THE COUNTY OF CHESTER

Chester County Planning Commission

Government Services Center, Room 270
February 13, 2019

AGENDA

*Detail of Landscape Business Development
Final Land Development*

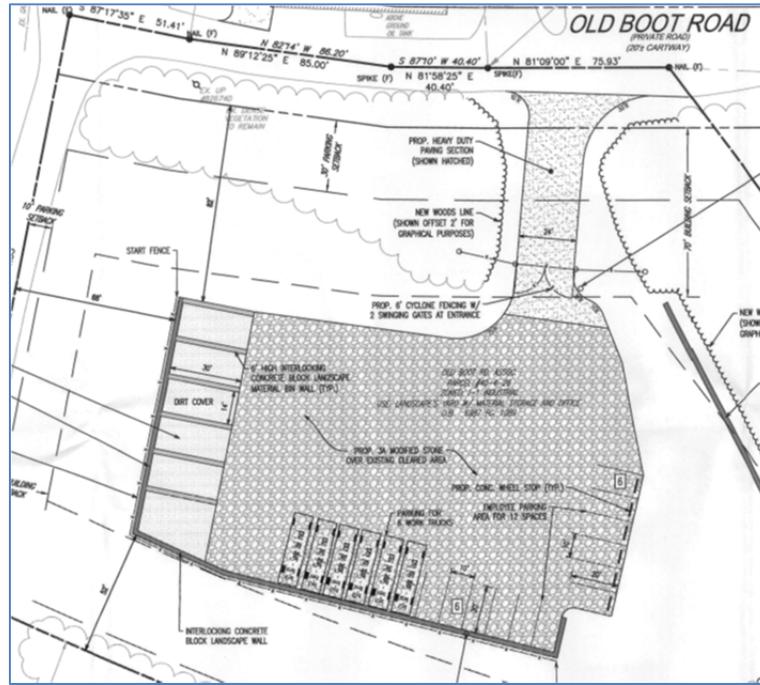
3. The plan indicates that the applicant obtained conditional use approval. Prior to granting final plan approval, the Township should verify that any conditions of approval are incorporated into the final plan. The conditional use conditions are shown on the plan, and we note that the conditions include provisions for limiting the on-site storage of materials, and include requirements for the maintenance of Old Boot Road, which is a private road.
4. We recommend that the applicant consider the need for oil/water separators in the stormwater management system. This would reduce the risk of spilled petroleum products from entering the stormwater system and possible contamination of the watershed.
5. The Township may wish to inquire how dust from the stone parking area will be controlled.

Detail of Glenn and Dahnielle Schmidt Preliminary/Final Subdivision

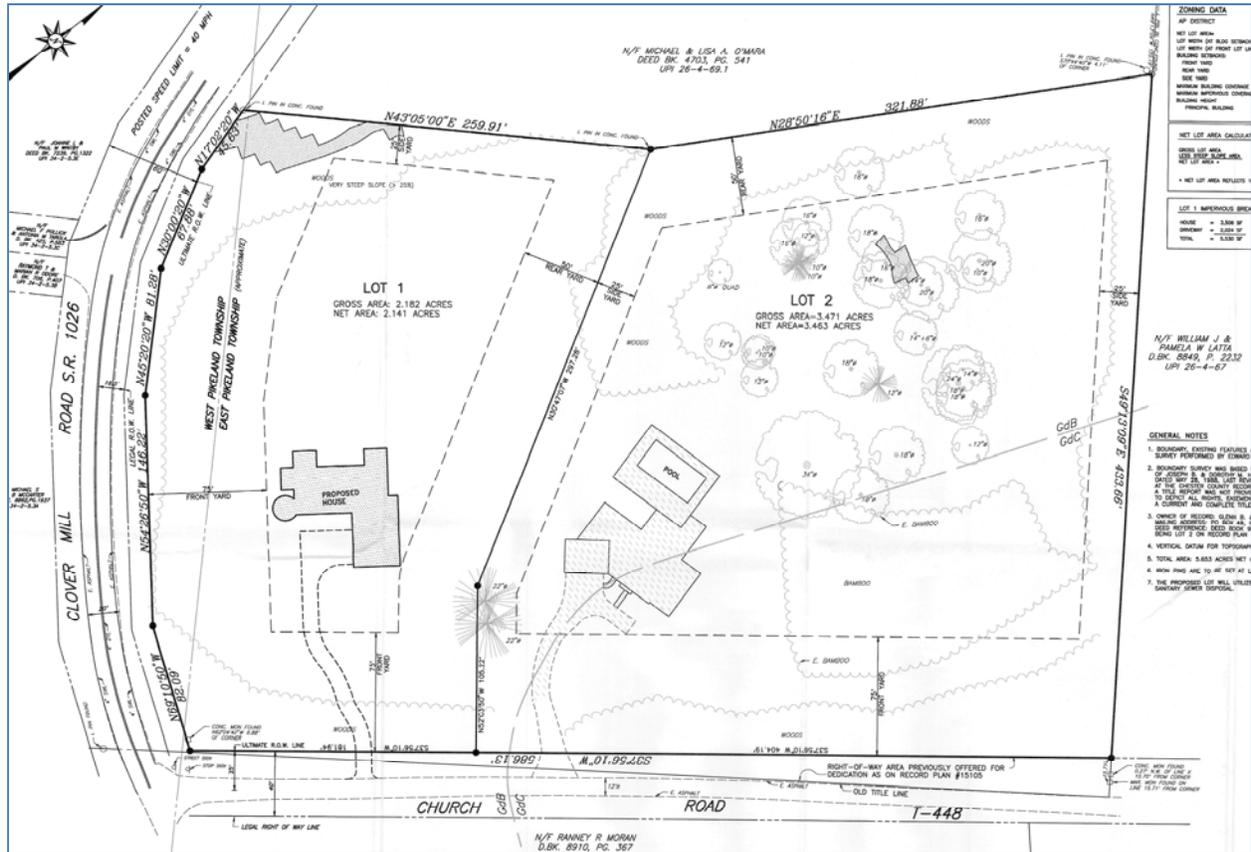
- The County Planning Commission’s Multimodal Circulation Handbook (2016 Update), which is available online at www.chescoplanning.org/resources/PubsTransportation.cfm, classifies Clover Mill Road as a minor collector. The Handbook (page 183) recommends an 80 foot-wide right-of-way for minor collector roads to accommodate future road and infrastructure improvements. We recommend that the applicant and the Township contact PennDOT to determine the appropriate right-of-way to be reserved for this section of Clover Mill Road. We suggest that this area be identified as a dedicated right-of-way, and be offered for dedication to PennDOT. Church Road is classified by the Multimodal Circulation Handbook as a local road with a recommended right-of-way of 33 feet; the plan shows an existing 40-foot right-of-way for Church Road.

5. A copy of the plan should be submitted to the Chester County Health Department for their review and comment on the proposed sewage disposal and/or water supply.
6. A minimum of five copies of the plan should be presented at the Chester County Planning Commission for endorsement to permit recording of the final plan in accord with the procedures of Act 247, the Pennsylvania Municipalities Planning Code, and to meet the requirements of the Recorder of Deeds, the Assessment Office, and the Health Department.

Site Plan Detail, Sheet 2: Buildings 9 and 25 Great Valley Corporate Center

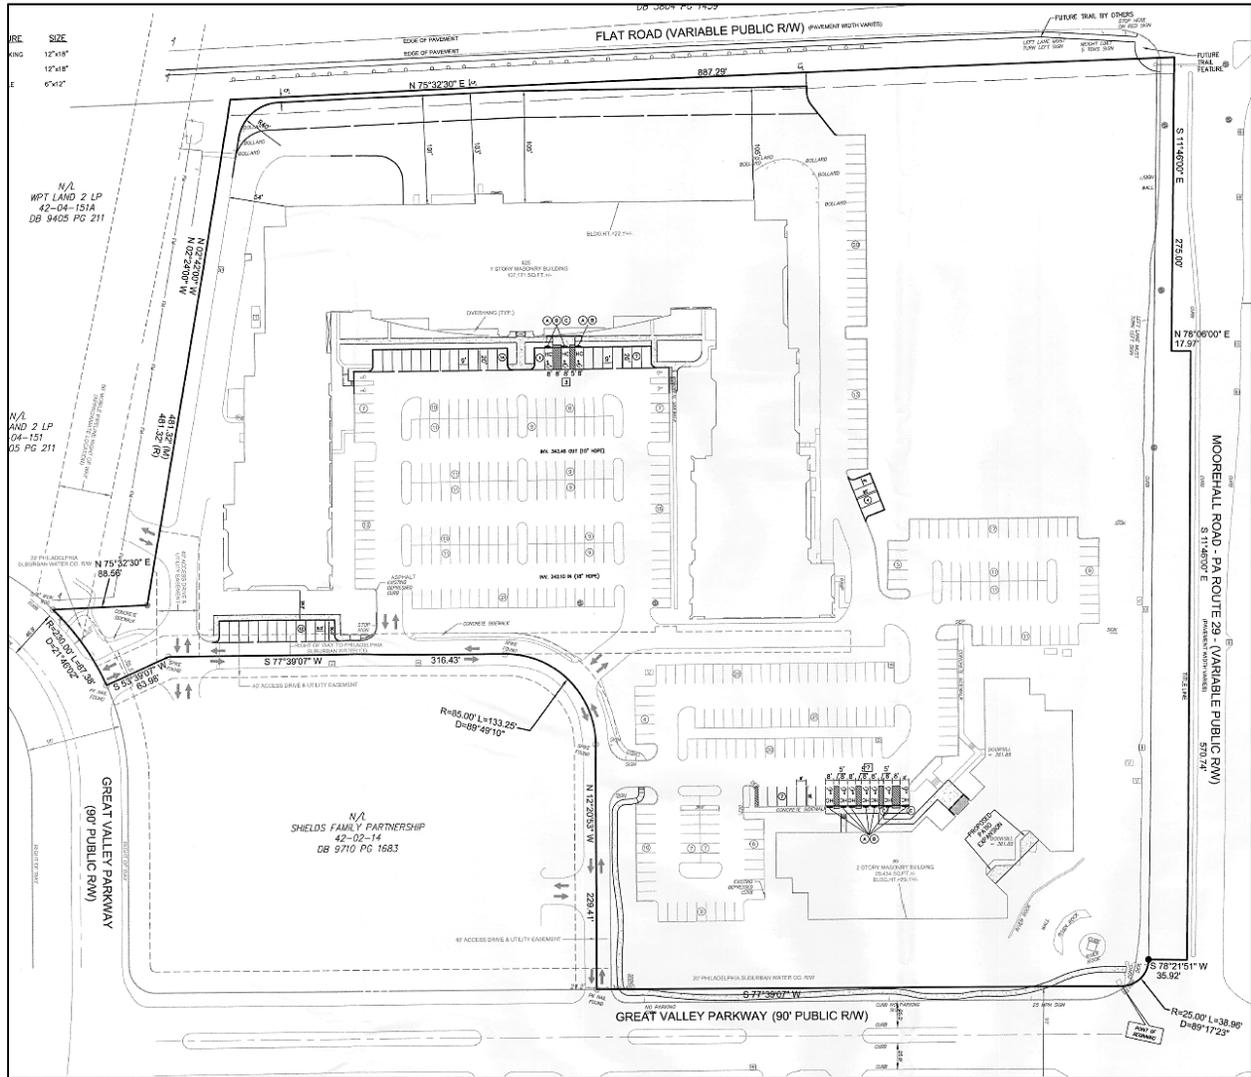
4. The site plan depicts a future trail location along Flat Road. We note that the Trails Plan (Map 1) in the Township Comprehensive Plan and the Proposed Township-Wide Trail System Map in the Township Park and Recreation Plan depict the location of a pedestrian corridor along Flat Road from Route 29 to Sidley Road. We suggest that the applicant and Township identify the location of internal pedestrian connections extending from the future trail corridor to the existing buildings as part of the current plan submission.

5. The site plan does not depict the location of pedestrian facilities along the Route 29 corridor, nor does it depict the location of crosswalks being provided at the Route 29/Flat Road/South Atwater Drive intersection, particularly the southern crosswalk leg. This should be clarified by the applicant. The Township should ensure that the design of pedestrian facilities along the Route 29 corridor is generally consistent with the *Great Valley/Route 29 Multimodal Study*. The Study recommends that a shared-use bicycle and pedestrian path be installed along the western side of Route 29, and that crosswalks should be installed on all four legs of the Route 29/Flat Road/South Atwater Drive intersection (it appears that only the eastern crosswalk leg has been constructed to date). The construction of these pedestrian improvements would permit direct pedestrian access from the project site to the Atwater Village Commercial development on the east side of Route 29. The Study is available online at:

7. The site plan depicts a 50 foot wide Mobile Pipeline right-of-way to the immediate west of the project site. We suggest that the applicant contact the pipeline operator to ensure that the application does not result in any encroachments into the pipeline right-of-way. It is recommended that the plan include the field survey location of the pipeline, the size, material and depth (if known), and the type of product typically being transported through the pipeline. Pipeline operator contact information is located on the pipeline markers within the easement and can also be found at the Chester County Pipeline Information Center Pipeline Operators page: www.chescoplanning.org/pic/introduction.cfm.

8. While Sheet 4-Conservation, Existing Conditions & Demolition Plan depicts the location of 15 parking spaces to be removed, as noted in the Parking Calculations table on Sheet 2, it does not depict the existing parking area at the rear of Building #25 where the expanded truck court will be located. This should be clarified by the applicant.

12. The Zoning Hearing Board decision on Sheet 2A identifies that, on June 25, 2018, the Township Zoning Hearing Board granted a variance from the minimum setback requirements from street rights-of-way for surface parking or paved areas adjacent to local streets, with four conditions of approval. Prior to granting final plan approval, the Township should verify that the plan conforms to the decision issued by the Township Zoning Hearing Board.

Site Plan Detail, Sheet 4: Preliminary/Final Subdivision - Frazer Lanes Redevelopment

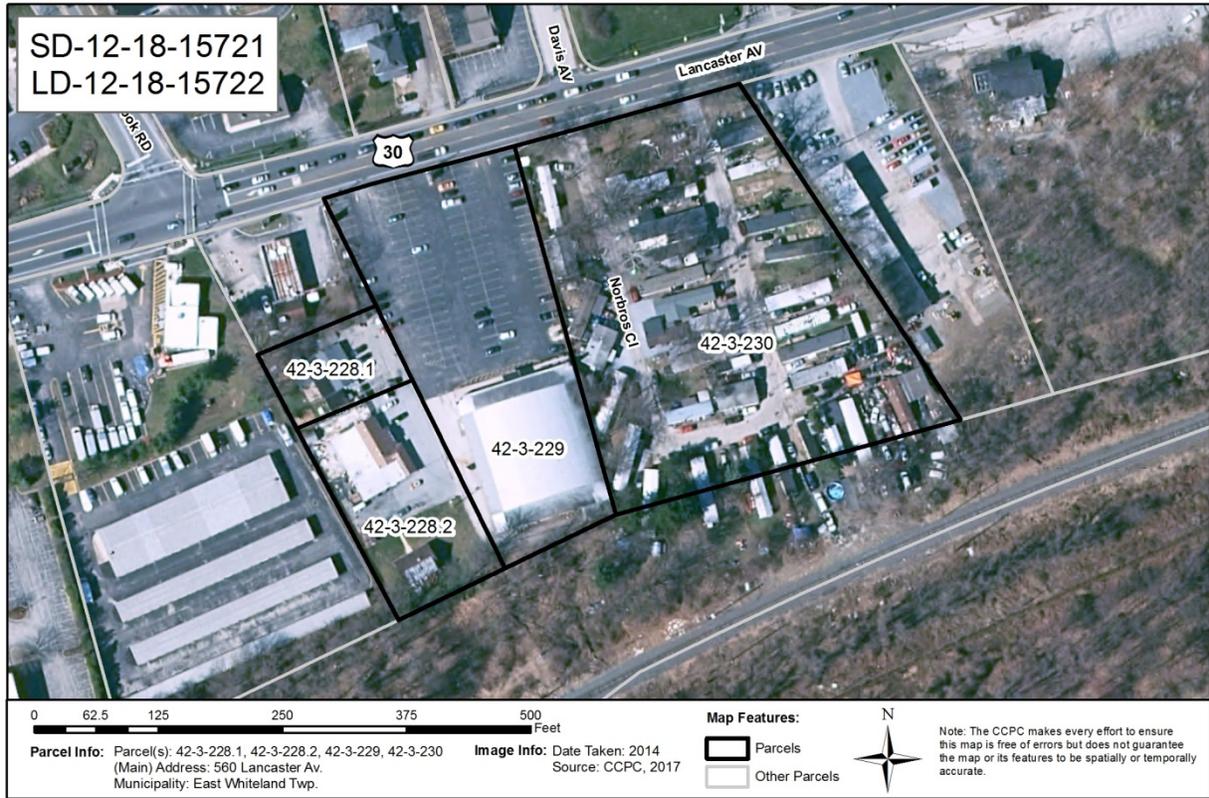
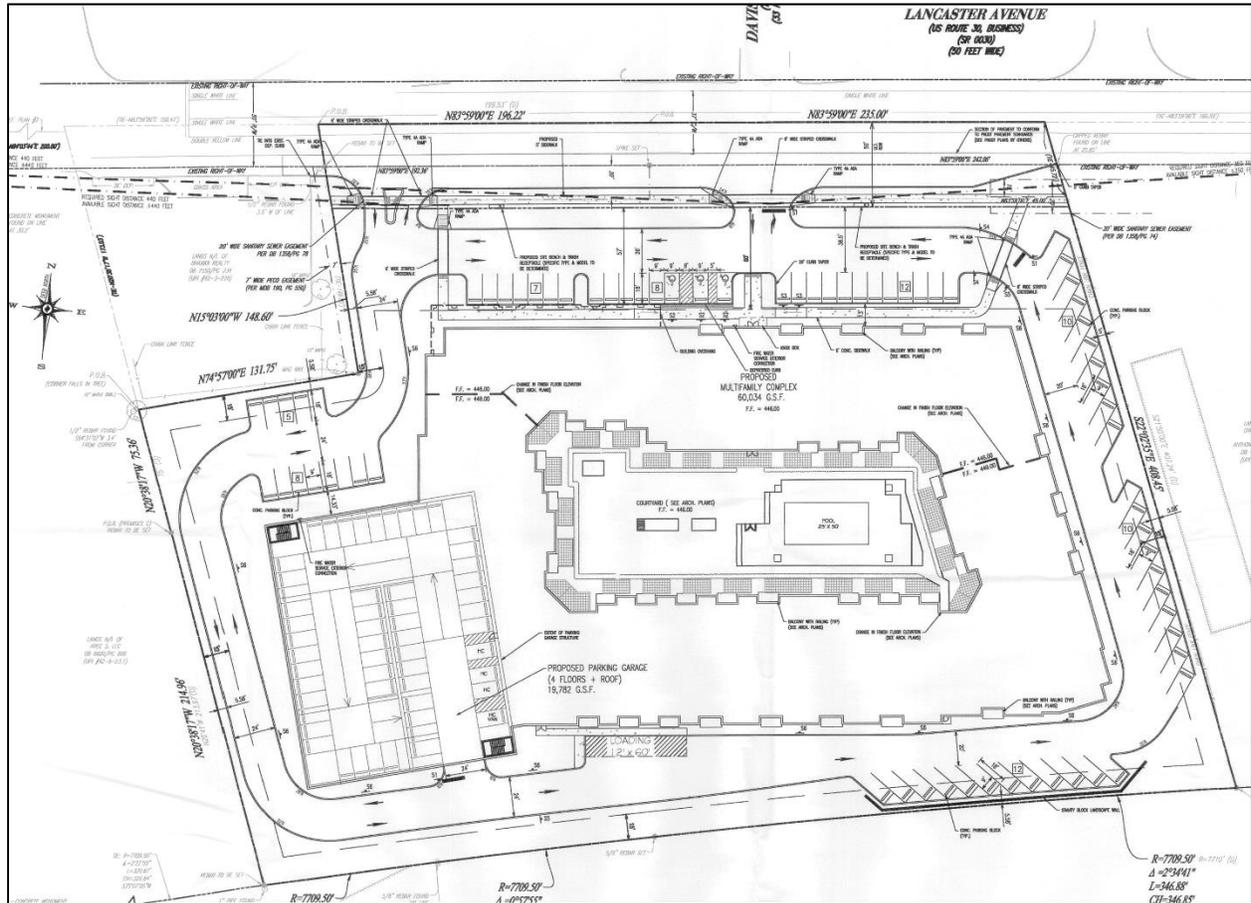
5. The Township’s emergency service providers should be requested to review the plan to ensure that emergency service vehicles will be able to safely navigate the proposed development when completed. We note that a vehicle turning plan for fire trucks is provided on Sheet 16.

11. In its review of the proposed landscaping plan (Sheet 18), the Township should verify that sufficient room is provided along the adjoining parcel boundaries for adequate buffering from the adjoining land uses.

13. The Township should verify that the design of the proposed outdoor lighting plan (Sheet 17) conforms to Township ordinance requirements. The illumination should be directed inward from the periphery of the site and be oriented to reduce glare and visual impact on the adjoining roadways and land uses.

Detail of Sheet 3 of the plan

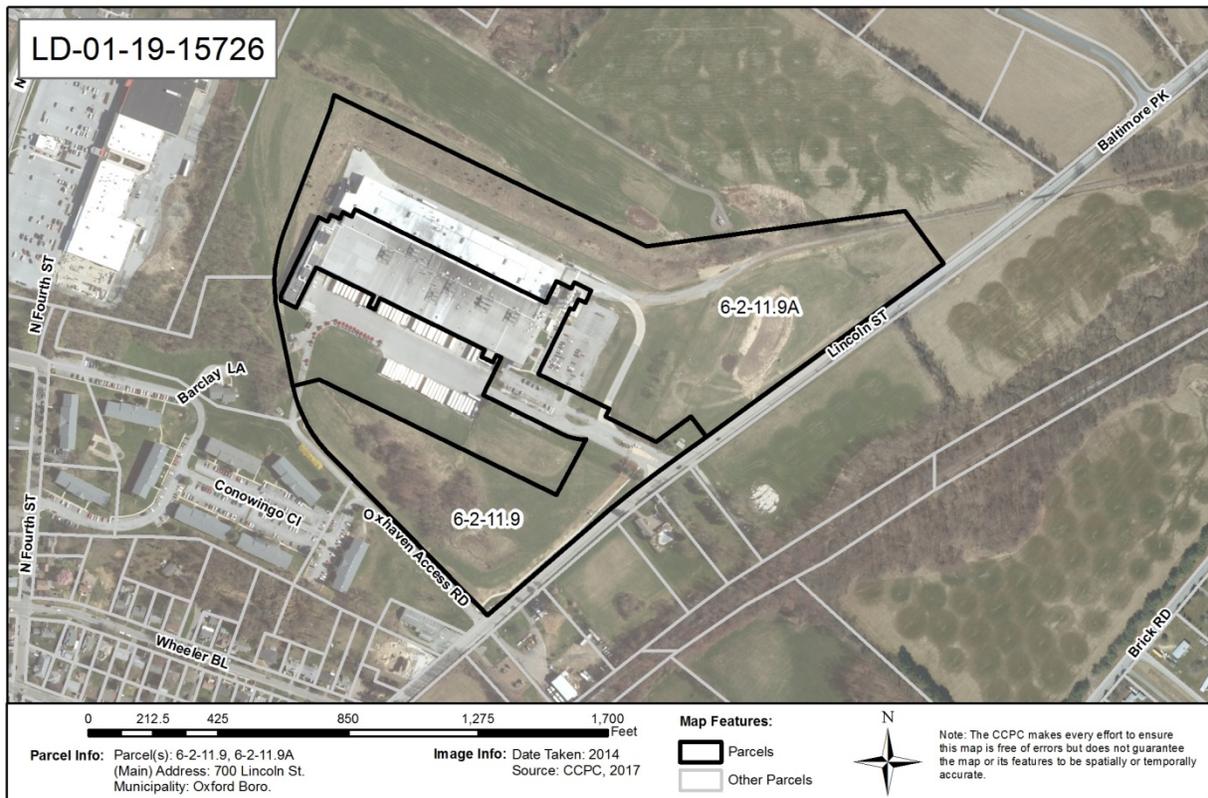
4. There appears to be an inconsistency between the proposed building coverage on the cover sheet (30,750 sq. ft.) and that listed on Sheet 3 of the plan (43,050 sq. ft.). The applicant should verify these figures and revise them as necessary.

Site Plan Detail, Sheet 1: Preliminary Subdivision – Jeffrey Daily

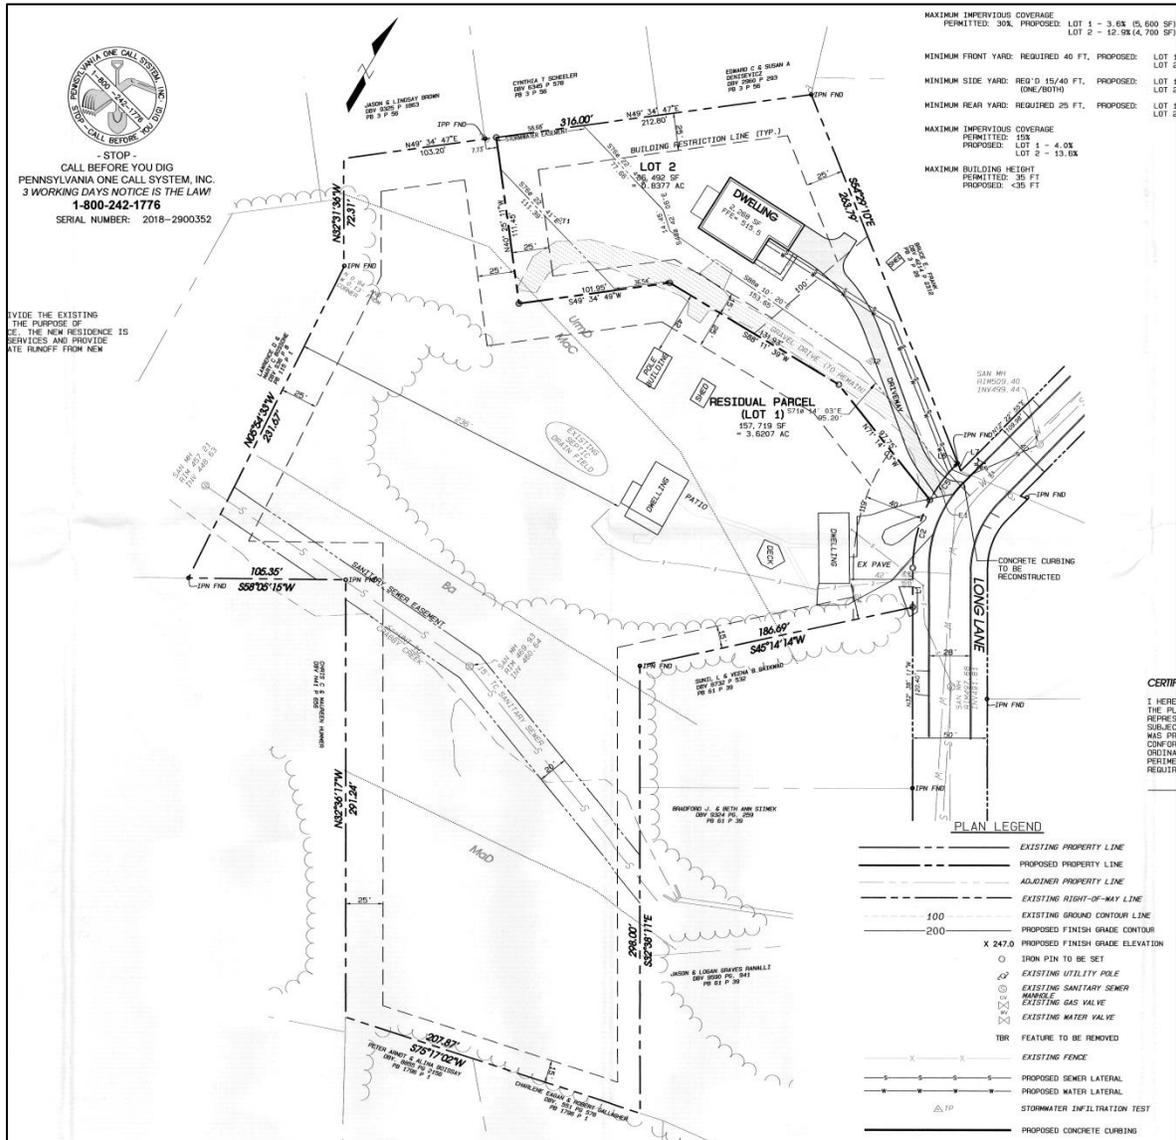
7. The Stormwater Management Facility Ownership and Maintenance note on Sheet 1 states that the homeowner is responsible for the perpetual maintenance of the stormwater management facilities. Ongoing efforts by the municipality may be needed to educate homeowners so that they can fully understand and fulfill their operation and maintenance requirements for these facilities.

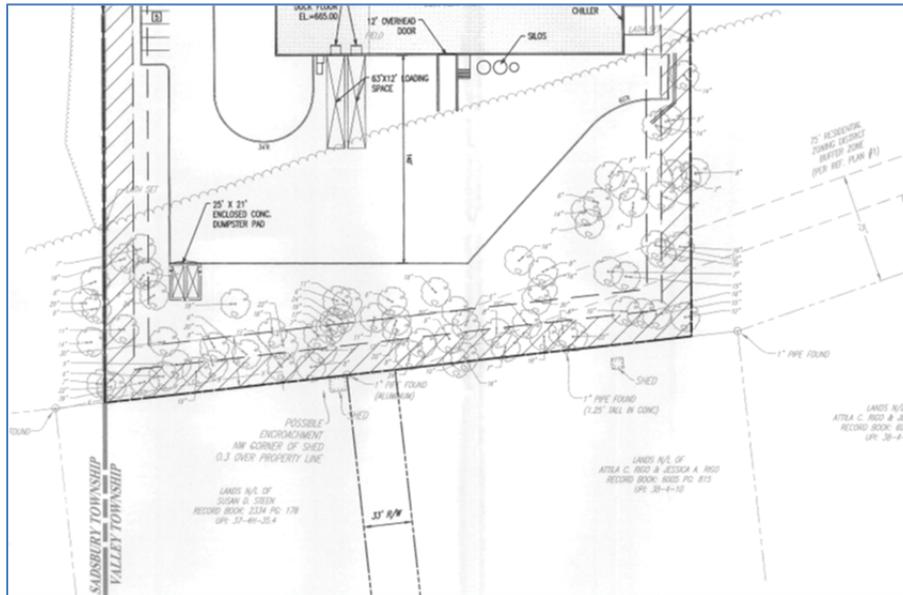
4. We recommend that special attention be applied to the landscaping and lighting at the south of the site due to the proximity of the nearby residential area. Truck movements in this area, especially if conducted early or late in the day, may disturb residents in this area. A short fence to shield truck headlights could also be considered along the southern portion of the site (see the detail below).

Site Plan Detail, Sheet 2: Final Subdivision - Timothy Kanavy

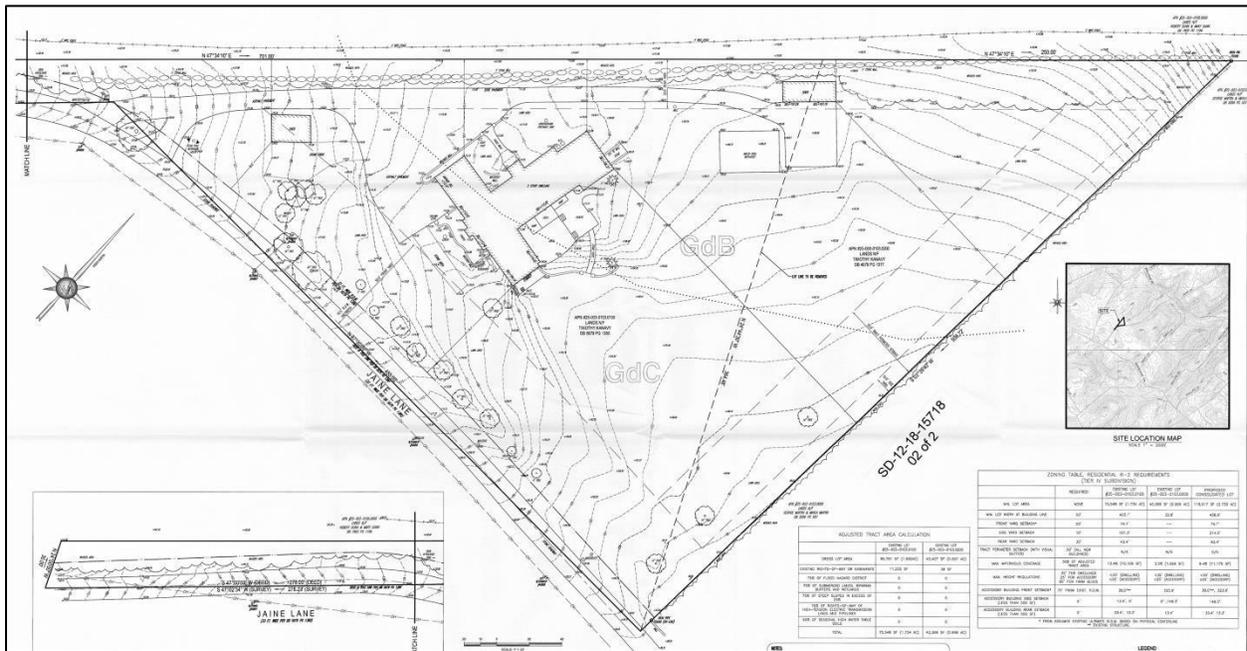
1. The Chester County Planning Commission signature block on Sheet 1 and Sheet 2 should be revised to indicate that the plan has been endorsed for recording by the Secretary, rather than the Director, of the County Planning Commission.
2. A minimum of four (4) copies of the plan should be presented at the Chester County Planning Commission for endorsement to permit recording of the final plan in accord with the procedures of Act 247, the Pennsylvania Municipalities Planning Code, and to meet the requirements of the Recorder of Deeds and the Assessment Office.
